UNION PACIFIC RAILROAD COMPANY

November 18, 1991

Grade Separation:
AR: McGehee
Highway 65 O.P.
M.P. 407.50 Wynne Sub
(State Job 20021)

Please reference your letter of October 28, 1991, addressed to Mr. S. J. McLaughlin, transmitting revised plans for the replacement of the overpass at the above location.

FIGURE 1
 PIER PROTECTION

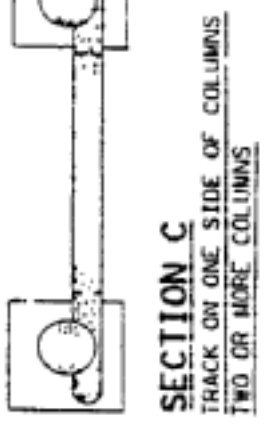
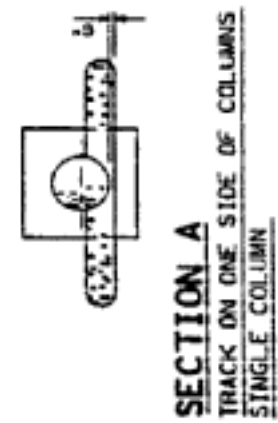
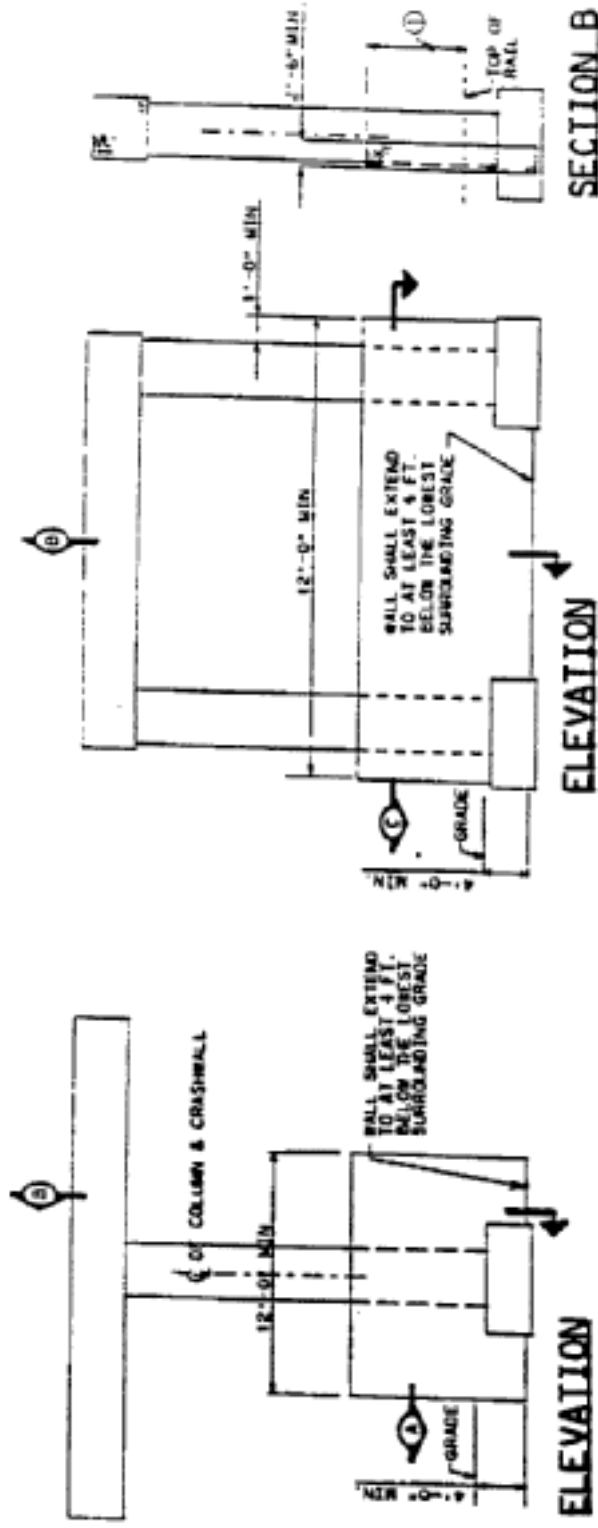
Please revise the plans to show a minimum 6' between base of rail and top of proposed footing, and include complete dimensions of footings. As the proposed piers are within 25' of centerline, it is requested that crashwalls be included, or that additional detail be provided on the exhibit to show the piers are in compliance with AREA 2.1.5.1, copy attached. Also attached is Dwg. 106613, Shoring Requirements and Dwg. 82495 Barriers and Clearances, for future reference.
